**Job Name:** Land East of Lunce's Hill, Haywards Heath, West Sussex  
**Job No:** 332611520  
**Note No:** 001  
**Date:** September 2025  
**Prepared By:** B Haydon  
**Reviewed By:** N Fern  
**Subject:** Transport Addendum Note – in response to West Sussex County Council Highways and West Sussex County Council Waste  
**Planning Reference:** DM/25/0827

## 2. Response to WSCC Highways Comments

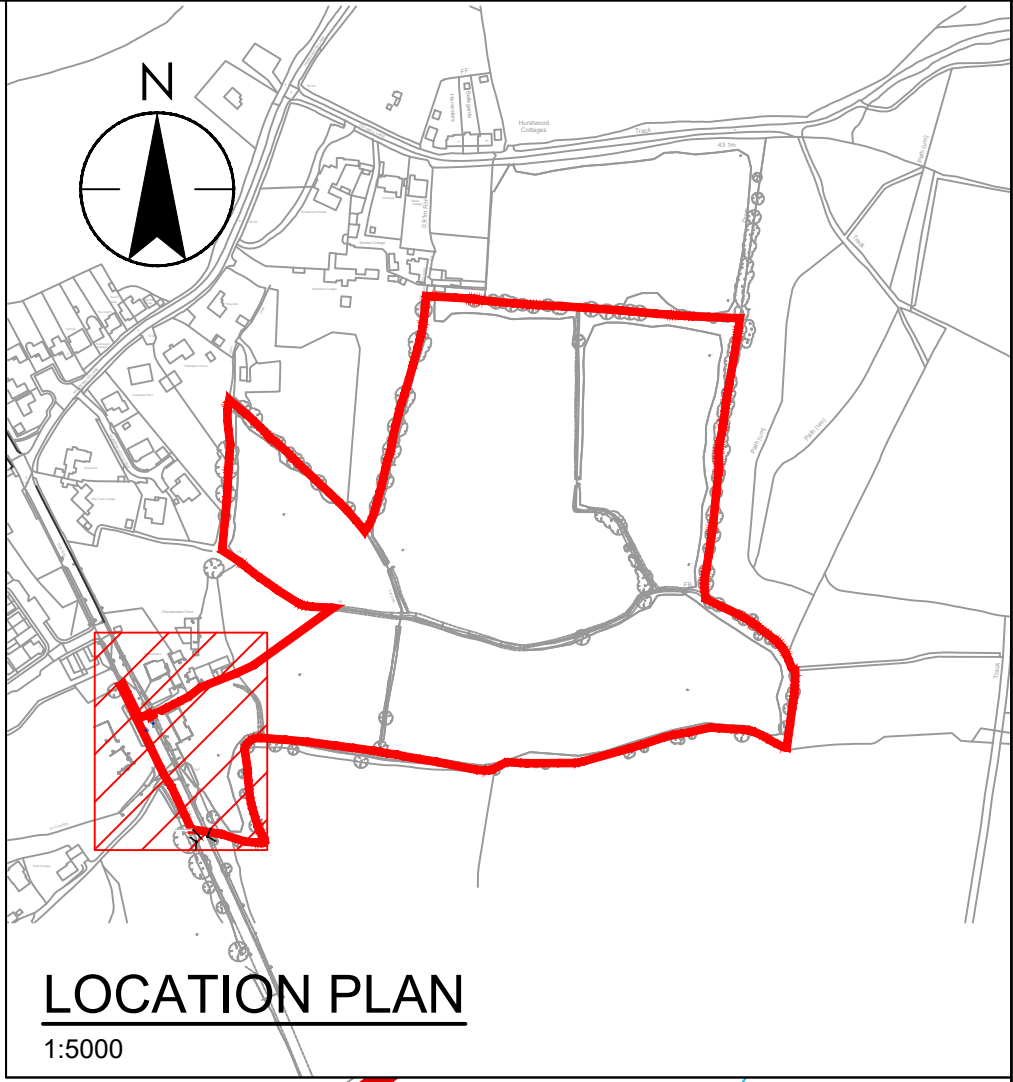
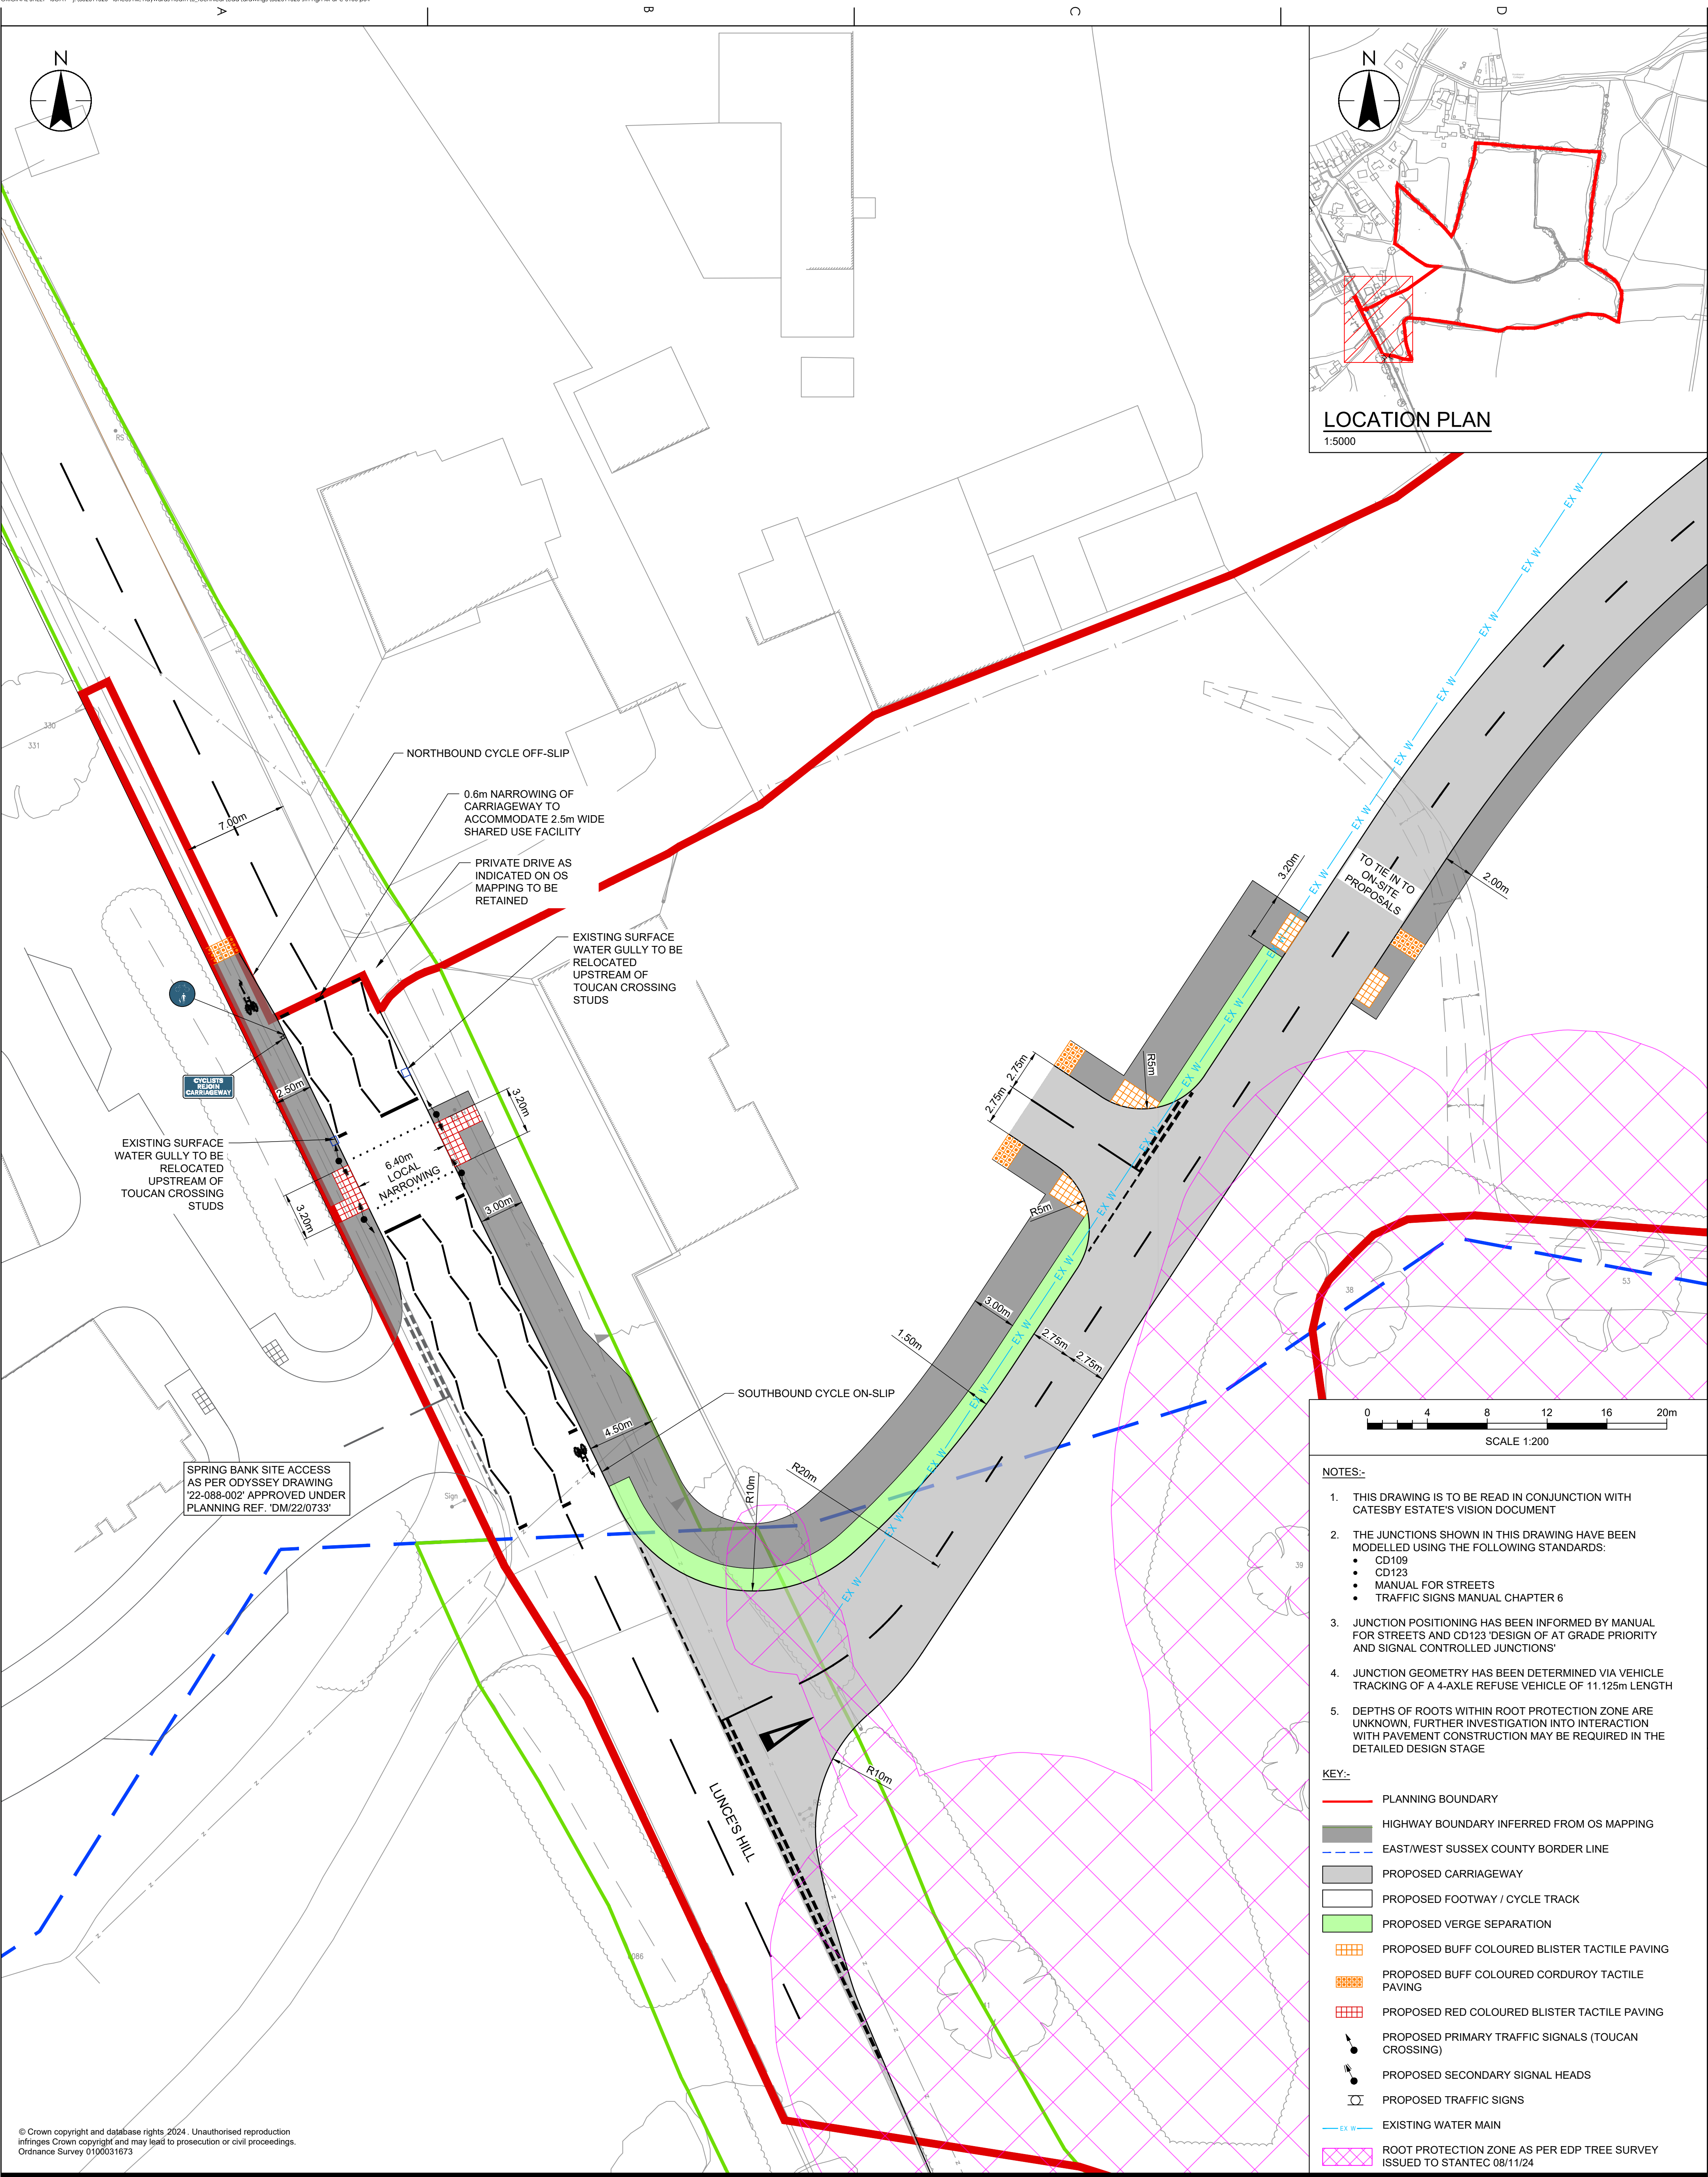
*"The swept path analysis assessment has been done using vehicle measurements of; Length 11.125m and width 2.530m. Please take into consideration that our vehicles are 12m - length and 2.6m – width. There will need to be sufficient space for vehicles of this size to safely access and manoeuvre for collections."*

*"In the Design and Access statement Part 1, Parking and refuse strategy, it states that, all roads have been designed to adhere to adequate widths and turning to accommodate refuse collection vehicles. We will need a sweep path analysis for our size vehicles for the whole development site, not just for access to get onto the development. We need to know if our vehicles will be to able access and safely manoeuvre on all roads for us to be able to provide our services for all residents."*

- 3.1. The Swept Path Analysis submitted in Appendix F of the Transport Assessment have been updated for the larger vehicle detailed in the Waste team's comments and are provided in **Appendix F** of this Technical Note.
- 3.2. The results of this assessment have demonstrated that this larger refuse vehicle would be able to suitably access the Site via the proposed access arrangement.

- 3.3. At this stage in the outline planning process, with all matters reserved except for access, the internal road layout is not fixed, with any roads shown on the illustrative masterplan indicative and subject to change.
- 3.4. Therefore, at this stage with no definitive internal road layout, we would not carry out swept path analyses for the entire Site.
